[Docket No. 91-ANE-29; Amendment 39-9470; AD 91-21-01 R1]

Airworthiness Directives; Textron Lycoming Model TIO-540-S1AD Reciprocating Engines

ACTION: Final rule; request for comments.

APPENDIX I
91-21-01 R1

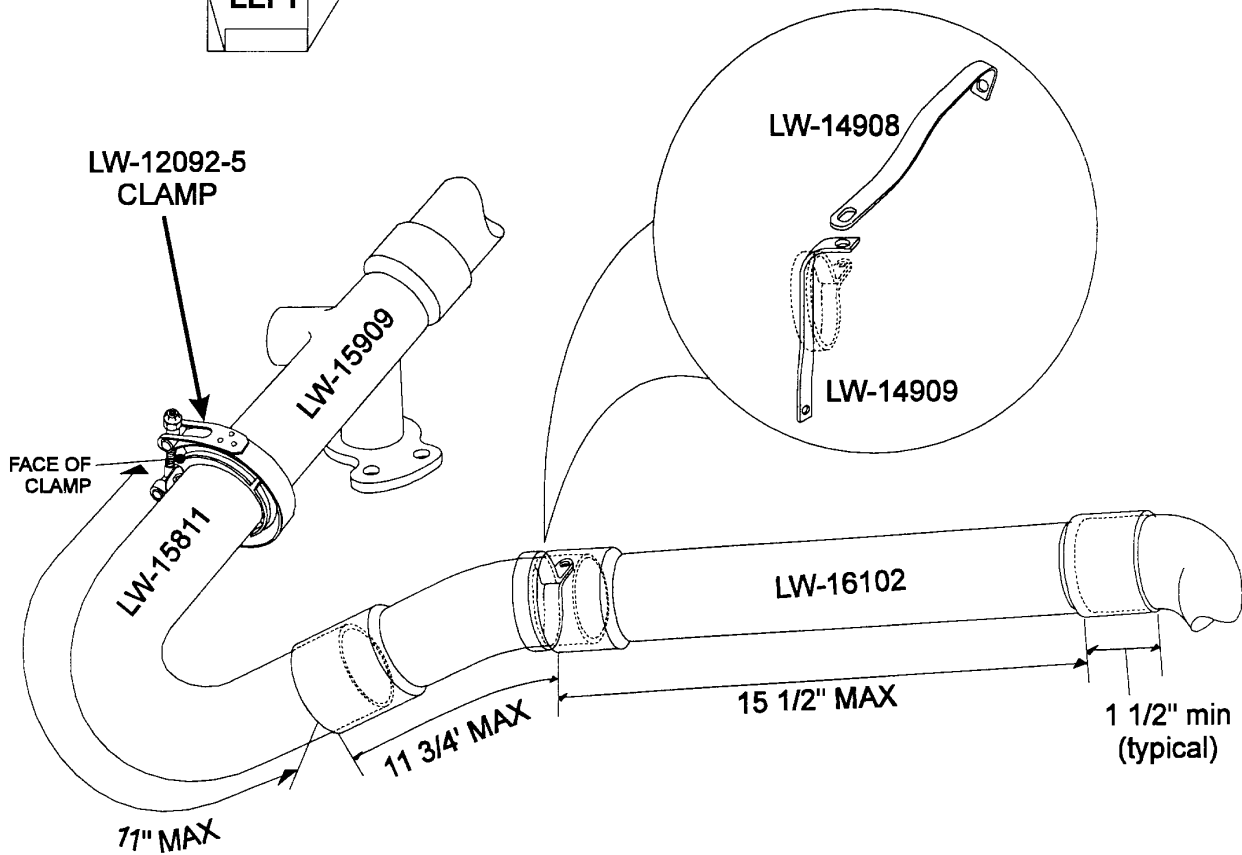
(ii) Inspect the exhaust system for proper slip joint engagement by measuring distances between pipe end points in accordance with Appendix 1 of this AD.

(ii) Thereafter, at intervals not to exceed 100 TIS, perform exhaust system inspections specified in paragraph (a)(2)(i) and (a)(2)(ii) of this AD. Operators need to determine the minimum engagement of only exhaust pipes LW-16102 and LW-16103 by referring to Appendix 1 of this AD.

(iv) Reassemble and align exhaust system in accordance with Textron Lycoming SB No. 484, dated January 30, 1989, and Appendix 1 of this AD.
